Review of the inputs of Professor David Smythe in relation to planning applications for shale gas development in Lancashire (planning applications LCC/2014/0096 /0097 /0101 and /0102) and associated recommendations

Professor Paul L. Younger FEng
and

Dr Rob Westaway
School of Engineering, University of Glasgow, Glasgow G12 8QQ.

17 December 2014

Fig. 1. Cross-section illustrating the geometry of the faulting in the vicinity of the Preston New Road site, from Fig. 6 of Appendix L of planning application /0096

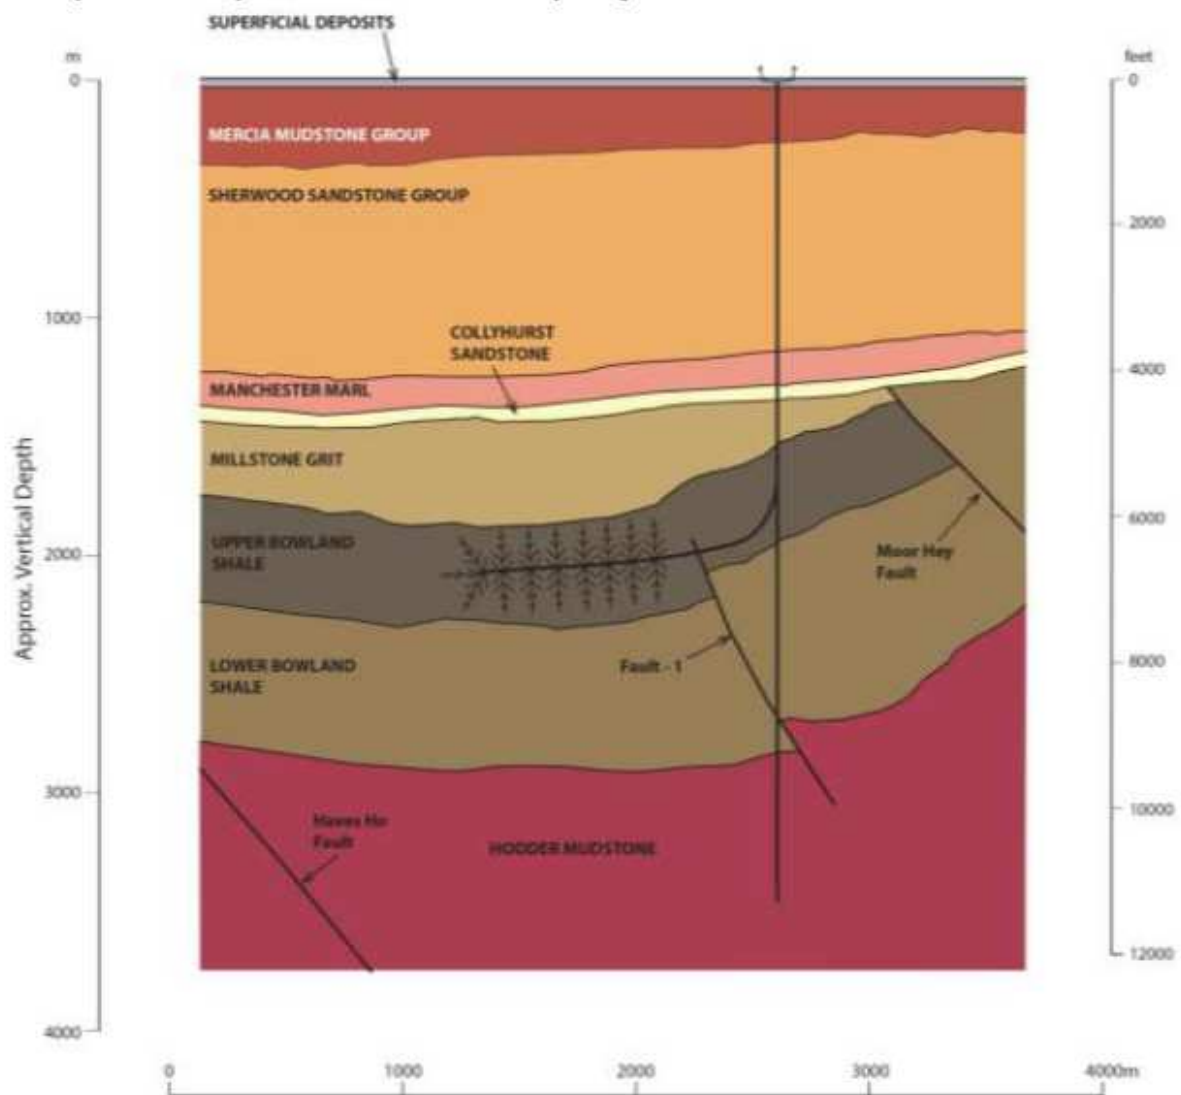
The last of Professor Smythe's issues, that some of the fault interpretation by Cuadrilla may well be incorrect, also has no significant consequences. He has argued that the interpretation of Fault 1 in Fig. 1 makes no sense and that this fault more likely continues upward through the Bowland Shale and the overlying Millstone Grit, dying out at the unconformity between that and the younger sediments above. He is probably correct about this; at any locality in northern England (see De Paola et al., 2005, and others) the most likely timing of reverse slip such as this is during the Variscan orogeny (i.e., ~300 million years ago), after the Millstone Grit was emplaced but before the younger deposits were laid down. This means that the vertical extent of this fault should be estimated as ~1.8 km rather than the ~1.3 km indicated by Cuadrilla. However, whether it is ~1.3 km or ~1.8 km, it is still an important fault with implications for the hazard of undertaking the project in this area.

Of greater potential significance to the present planning applications is the second type of induced earthquake, involving the lubrication by fracking fluid of pre-existing faults. It is apparent that the proposed fracking operations are planned to occur within ~100 m of important faults (Figs. 1 and 2). Professor Smythe has written '**Cuadrilla has defined so-called 'regional' faults, which will be avoided by the fracking operations, and 'local' faults, through which drilling and fracking may take place. Its definitions are inconsistent and illogical. All faults should be avoided, whatever the scale; if this results in the Bowland Basin being unexploitable for shale gas, then so be it.**' Cuadrilla thus regard the Woodsfold Fault depicted in Fig. 2 as 'regional' and so to be avoided; thus the Roseacre Wood site has been chosen to be more than a kilometre away from it (Fig. 2). However, Professor Smythe is entirely correct to note the illogicality of attaching less importance to the other faults, from the point of view of induced seismicity, when they are of sufficient size to rupture in damaging earthquakes. We nonetheless consider his second sentence to be itself illogical: faults should be avoided IF they are large enough to slip in damaging earthquakes and IF the effects of fracking have a demonstrable likelihood of bringing the fault to the condition for shear failure.

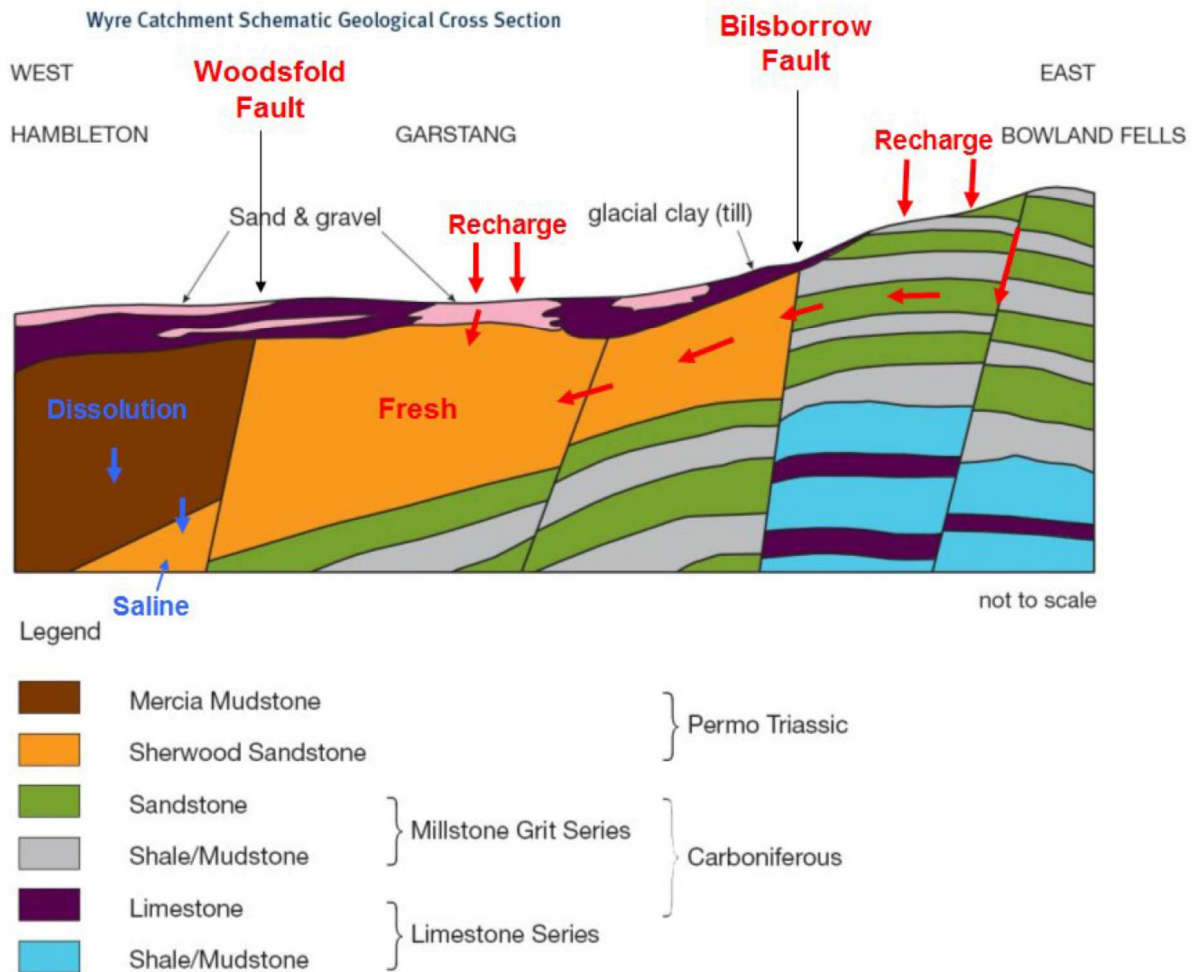
As regards the third issue, groundwater / surface water pollution risks, Professor Smythe has claimed that **'The hydrogeology of the area immediately east of the site shows that regional faults are transmissive.'** The annotated version of an Environment Agency cross-section relating to the Sherwood Sandstone Group is presented and discussed by Professor Smythe, and is repeated here as Fig. 3. The argument he is basing upon this diagram is nowhere explained in detail, but it would appear that the point he is attempting to make is that, if the Woodsfold Fault is transmissive where it cuts sandstones, faults must also be permeable where they cut the Bowland Shale at greater depth. Professor Smythe thus considers that all geological faults should be regarded as leaky unless proved otherwise. He implies that this is the standard assumption made in hydrogeological investigations. However, this is not so. There are at least three issues here which Professor Smythe fails to consider:

- (i) Where faults cut low-permeability strata such as shale (and even locally where the fault passes from a shale into a more permeable bed) there is a marked tendency for the fault plane to be lined with a fine-grained clay-rich material known as "fault gouge", which typically renders these portions of the fault planes effectively impermeable (e.g., Younger 2007). In contrast, where the same fault cuts a permeable rock such as sandstone (and the displacement has not smeared clay-rich gouge from an over- or under-lying mudstone into the fault zone, then the fault plane may well be occupied by relatively permeable breccia; minor fractures either side of the fault plane in a sandstone might also be relatively clean and open. This explains where the faults cut sandstones in the recharge area described by Professor Smythe (Fig. 3) they are believed to be permeable. HOWEVER, because of the formation of fault gouge where the same faults pass down into mudstones, there is no *a priori* reason to suppose that these faults are permeable throughout their depths: where they cut mudstones they are overwhelmingly likely to be of low permeability.

- (ii) Even where a fault is not so lined with gouge as to render it impermeable, it is subject to the present crustal stress regime, which tends to favour faults being more permeable where they are aligned fairly closely to the current maximum compressive stress azimuth, but tends to

make them far less permeable if they are otherwise oriented (e.g., Ellis *et al.* 2014). Note that this does not override the basic permeability control provided by fault gouge.

- (iii) Crucially, even where a fault is continuously permeable over a large vertical interval (which is unlikely in sequences, like those in the region under consideration, that contain thick mudstones) groundwater flow can only occur if there is a sustained driving head from one area to another. There is no evidence of any such upward-oriented hydraulic gradient in this region, and the extremely short-lived pulses of increased head close to the boreholes during fracking operations are insufficient to overcome the head in overlying strata. Where conventional oil and gas reservoirs occur, natural upward hydraulic gradients may exist, but oil and gas only accumulate where permeable pathways upwards are insufficient to allow dissipation of fluid pressure over geological time. It is inherent in the very definition of UNCONVENTIONAL gas that such over-pressure does not occur – hence the need for reservoir stimulation and depressurisation of the target horizon in order to get gas to move into boreholes. These points were addressed in the Joint Royal Academies’ report (Mair *et al.* 2012), although Professor Smythe seems to have overlooked this.

It is for the above reasons that the actual consensus amongst hydrogeologists is that faults are *not* everywhere to be assumed to be permeable, let alone pathways for upwards migration of water in the absence of a driving head. Rather, faults are hydrogeologically ambiguous: the same fault can be impermeable where it passes through mudstone, and locally permeable where it cuts sandstones – provided of course it is oriented appropriately vis-a-vis the present crustal stress regime. In neglecting the above factors, Professor Smythe has failed to account properly for the most likely hydrogeological behaviour of the faults in the areas considered, at least as regards the overwhelming likelihood that they will be of very low permeability where they pass through the Bowland Shales. For this reason, the alarming scenarios of pollution of shallow groundwater and surface waters due to fracking operations, as suggested by Professor Smythe, are not credible. Consideration of fault permeability is also relevant to the decision by Cuadrilla to not attempt to propose drilling or fracking near the Woodsfold Fault but to propose these activities near other faults: the Woodsfold Fault has such great displacement that it offsets the impermeable Bowland Shale and juxtaposes potentially permeable rocks against it (Fig. 4), whereas the other faults have much smaller displacements and thus juxtapose Bowland Shale against Bowland Shale. In this respect, the Woodsfold Fault may well be hydrogeologically different from the others in the area. Professor Smythe moves on to suggest the drilling of several 1 km-deep boreholes to characterise the hydrogeology of the Woodsfold Fault, even though the planning applications specifically state that the projects are designed to avoid this particular fault. If his assertion that this fault plane is permeable is actually correct, drilling boreholes through it would introduce potential flowpaths where none currently exist; it might thus alter the pressure of groundwater within this fault in a manner that might affect the state of stress so as to make the conditions more conducive to this fault (or part of it) slipping in a future earthquake. Setting aside the expense of drilling such boreholes, this is therefore a foolish suggestion and demonstrates a lack of knowledge on the part of Professor Smythe. Although he has evidently not considered why the Woodsfold Fault should be regarded, from the point of view of hydrogeology, as different from the others, it should be noted that this aspect could have been explained much more clearly by Cuadrilla in the first place.

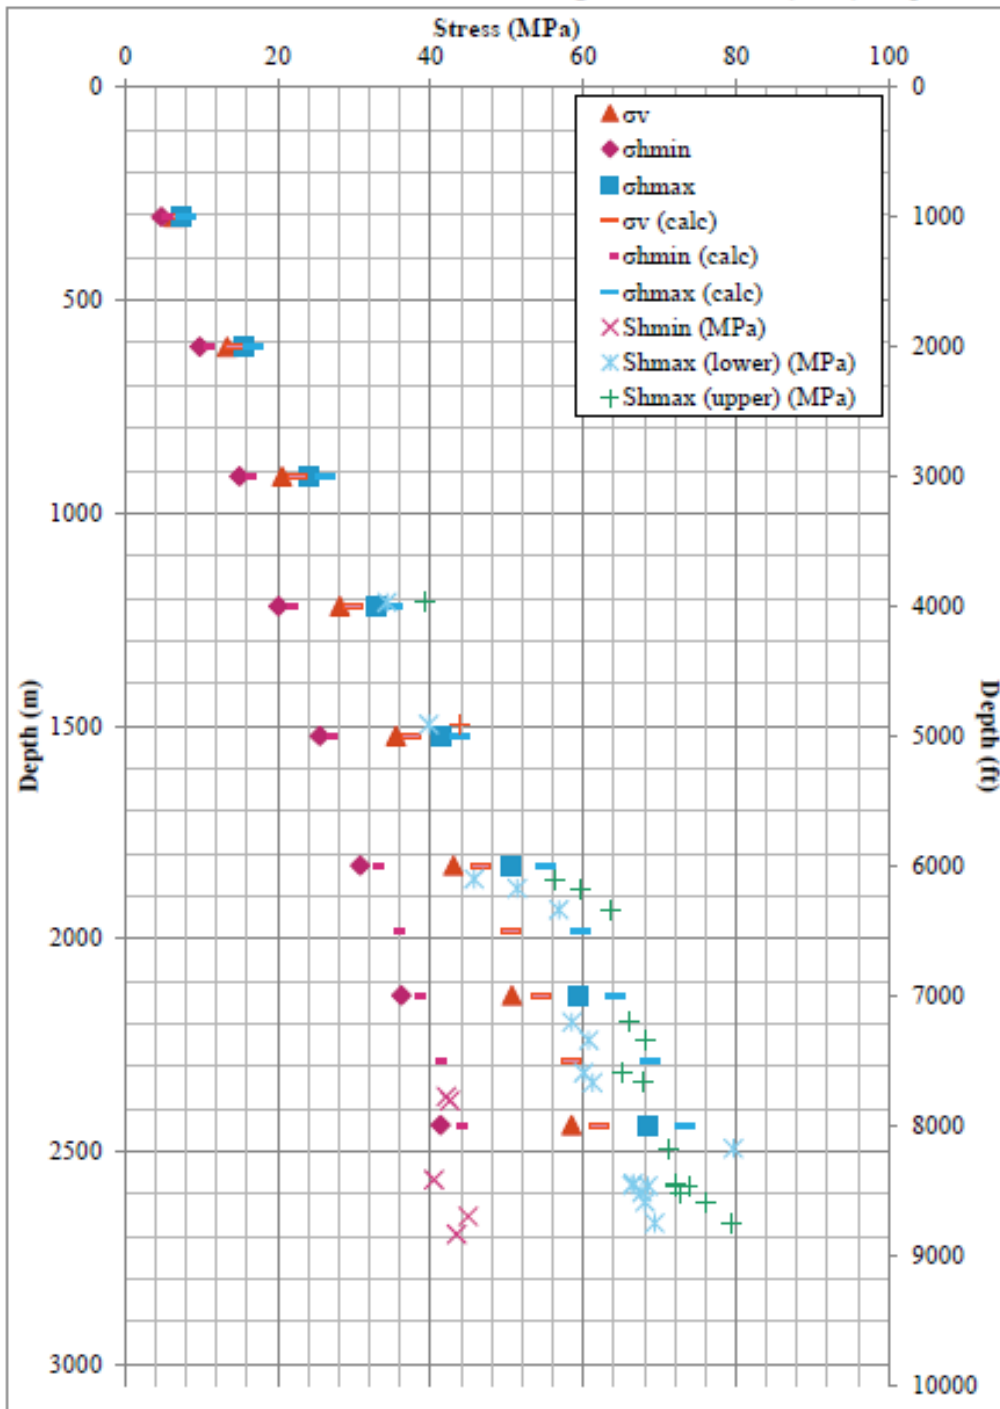
In their Appendix L documents for both planning applications Cuadrilla repeatedly mention mitigation measures but the essential point is that they state that the orientation and magnitude of the local stress field will be measured during the vertical drilling phase and will inform the applications for permission to subsequently begin fracking operations. This is stated on p. 45 of Appendix L of the Preston New Road planning application and p. 46 of Appendix L of the Roseacre Wood planning

application. On subsequent pages the documents disclose measurements of the state of stress at the Preese Hall 1 borehole (Fig. 5), which Cuadrilla consider representative of the proposed drilling sites. This is a reasonable starting assumption. Cuadrilla also propose to make multiple in situ stress measurements in their proposed boreholes, if these go ahead, during their initial vertical drilling phases, which is also a valid strategy. However, they then say that they will present the resulting data to DECC as part of making the case for being allowed to initiate fracking in these boreholes. This is not satisfactory; first, they do not present any calculations to demonstrate that the proposed projects are safe on the basis of existing stress measurements and plans. Second, it should be apparent that there is no-one at DECC with sufficient expertise to assess this type of technical argument, and since officials at DECC are open to political pressure, there is the possibility of interference in the decision. The correct time to present such a safety case is in the planning application; this is done below, where it is demonstrated that the proposed projects are safe provided the pressure used for the fracking is kept to the minimum necessary. Rather than being examined by DECC, a better strategy for examination of safety plans such as this is to make use of the expertise of academics, who include people with the most relevant skills and experience.

- The initial phase of vertical drilling should be accompanied by in situ stress measurements using an established technique (i.e., micro-fracking or overcoring). Representative samples of core should be collected, and should be subject to testing to determine the mechanical properties of the rock.

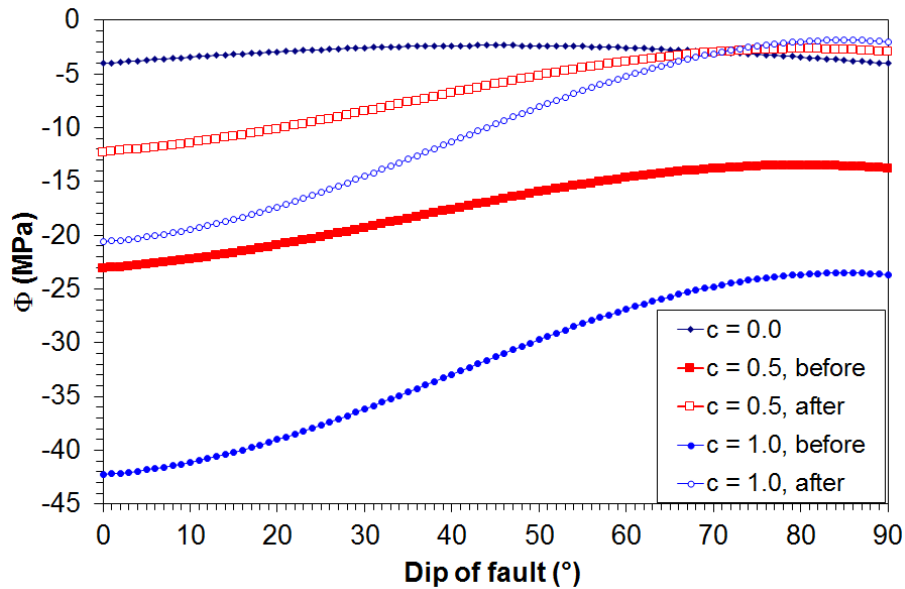
A first-order analysis of the safety case for the proposed project can be made using data from Cuadrilla's planning applications along with relevant theory from a standard textbook (equations 8-28 and 8-29 of Turcotte and Schubert, 1982) and from an appropriate publication (equation (3) of Westaway, 2006). The latter equation defines a 'failure parameter', called Φ , which can be calculated for any orientation of fault at any point in a rock mass; if $\Phi < 0$ then friction prevents the initiation of slip on this fault at this point, whereas if Φ increases to 0 at the point then slip is able to initiate at the point, and may propagate across the fault, potentially resulting in a large earthquake, the size of which is limited only by the overall area of the fault. For this analysis, we assume the best estimates of the three measured stress tensor elements from the Preese Hall-1 well at 2440 m depth of 62.2 MPa (σ_v – vertical stress), 73.4 MPa ($\sigma_{h \max}$ – maximum horizontal stress), and 43.6 MPa ($\sigma_{h \min}$ – minimum horizontal stress), reported in the planning applications. We also note that the maximum horizontal stress is reported at an azimuth of $173 \pm 7^\circ$, i.e., roughly north-south, and that the region is characterized by normal faults that are oriented roughly N-S and dip east of west. Cuadrilla have argued that any induced seismicity will involve strike-slip earthquakes, governed by the difference between $\sigma_{h \max}$ and $\sigma_{h \min}$, but given the orientation of the stress tensor and the faults this is incorrect; no faults in the area are suitably oriented to accommodate this sense of relative motion. On the contrary, the most likely induced seismicity will involve normal slip on these faults, which is governed by the difference between σ_v and $\sigma_{h \min}$. The possibility of normal fault reactivation is calculated by comparing, for a depth of 2440 m, an initial state where the water pressure is hydrostatic with a state during fracking where the excess pressure of fracking fluid affects the fault. The Bowland Shale is assumed to have a cohesion $S=4$ MPa and a tensile strength $T=2$ MPa (cf. Westaway and Younger, 2014). The minimum pressure of fracking fluid necessary to initiate fractures is taken as $\sigma_{h \min} + T$ and so is 45.6 MPa. The calculations are carried out for three values of the coefficient of friction of the fault, $c=0, 0.5$ and 1.0 , although in the first of these cases the changing fluid pressure makes no difference to the value of Φ . Calculations are carried out for all fault dips between 0 and 90° , encompassing the range of $\sim 35-70^\circ$ that is applicable to the faults in the area (cf. Figs 2, 5).

Figure 6 shows that for all conditions considered, the calculations indicate that the proposed project is safe; for no combination of fault orientation and coefficient of friction does Φ rise to zero.

Fig. 7. Alternative solutions for which the fracking fluid is assumed to be at a pressure 5 MPa higher than was assumed for the calculations for Fig. 6.

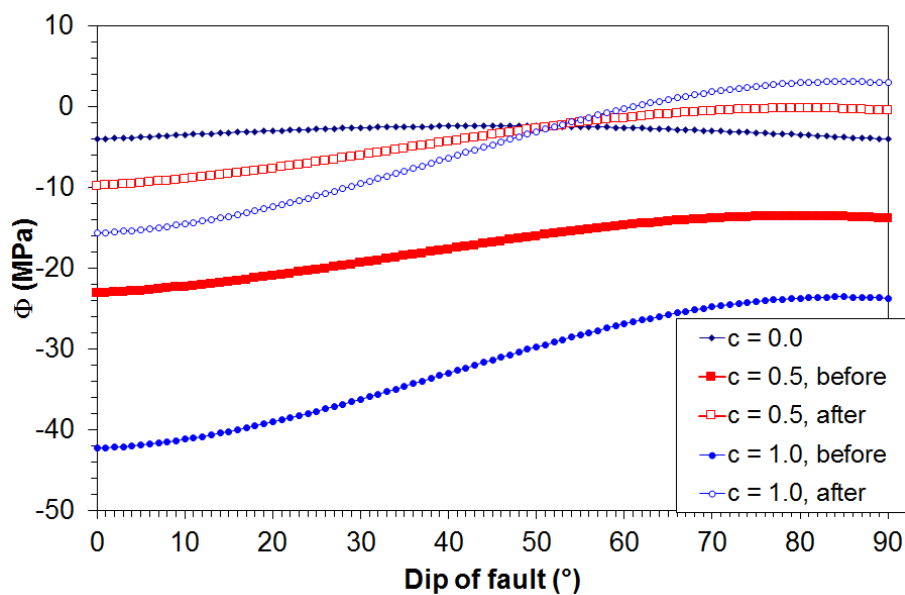
However, Fig. 7 shows an alternative set of calculations, in which it is assumed that the fracking fluid is at a pressure 5 MPa higher than for the previous set of solutions. In this case, it is predicted that Φ can exceed 0 for $c=1.0$ provided the fault dip is 61° or steeper. Since the Thistleton Fault is steeper than this (Fig. 2), this set of conditions might well result in an induced earthquake on this fault. The implication of this analysis is that for the project to be safe, Cuadrilla must be required to limit the pressure of the fracking fluid used in their fracking operations.

- The above-mentioned analysis will result in the determination of the maximum pressure of the fracking fluid that can be considered 'safe' for these projects. Cuadrilla could then be required to adhere to this limit.
